TECHNICAL BULLETIN

REF NO: 104.95

PRODUCT: VF7-10 VIEWFINDER FOR HK-366 / HK-377

SUBJECT: RASTER SCAN SIZE SWITCHING

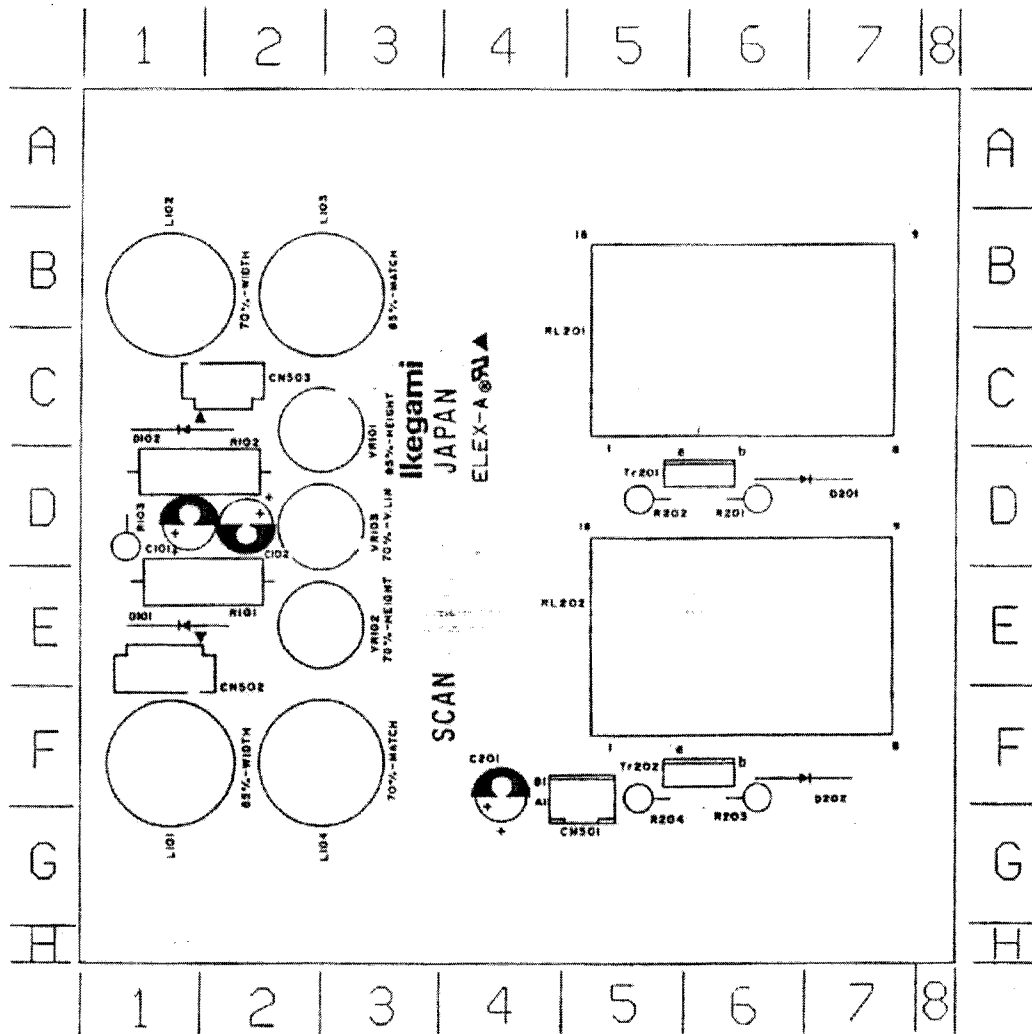
The following modification should be used if erratic operation of the SCAN SIZE select feature is encountered.

1. Locate the VF SCAN BOARD
2. Remove resistors R201 and R203 (see figure #1)
3. Replace these resistors (10K Ω) with 6800 Ω 1/2W resistors (Part# ERDS1VJ682T or equivalent)

This completes this procedure. No additional adjustments should be necessary.
